City of Santa Fe, New Mexico

memo

FROM: Paul A. Duran, Senior Planner, Historic Preservation Division

2025-010945-HDRB, 549 ½ Agua Fria St., Westside Guadalupe Historic District, Contributing, Robert Kreger, agent for Catherine Wynne, owner, requests approval of a 240 sq. ft. addition on the north elevation to a height of 12' where the maximum allowable is 17'-5".

Figure 1. Building Height Calculation.

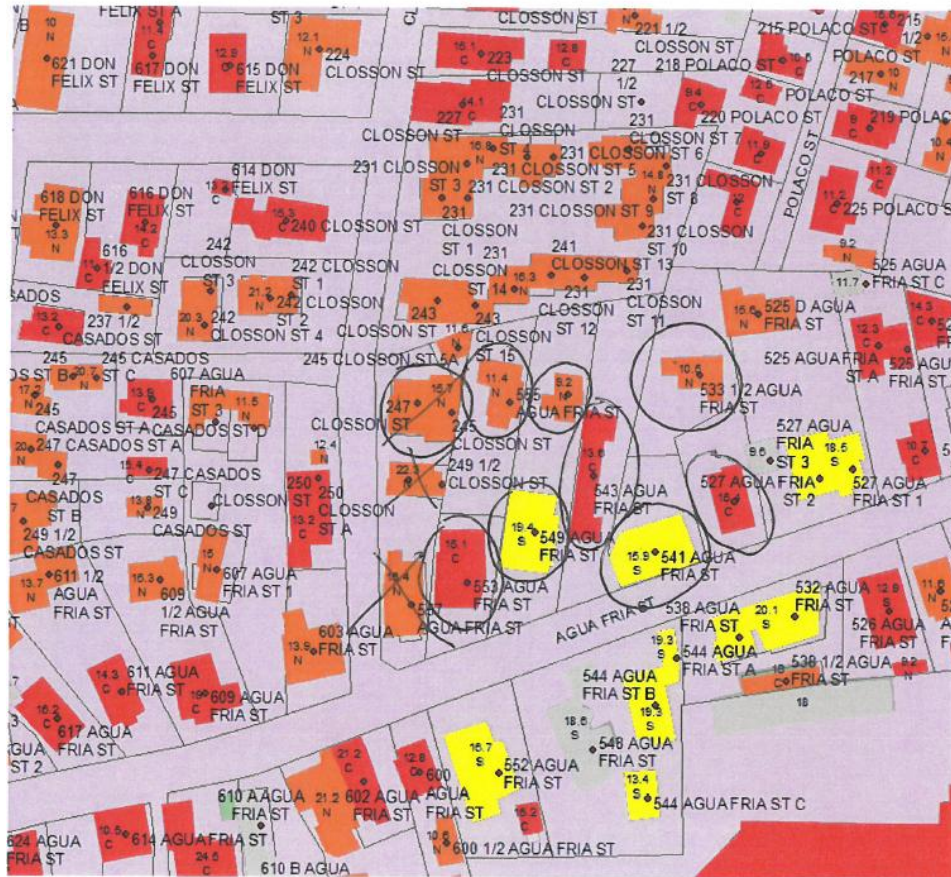
Building Height Calculation:

Total: 125.8 Count: 9 Avg.: 13.9 Max Allowable: 15'7"
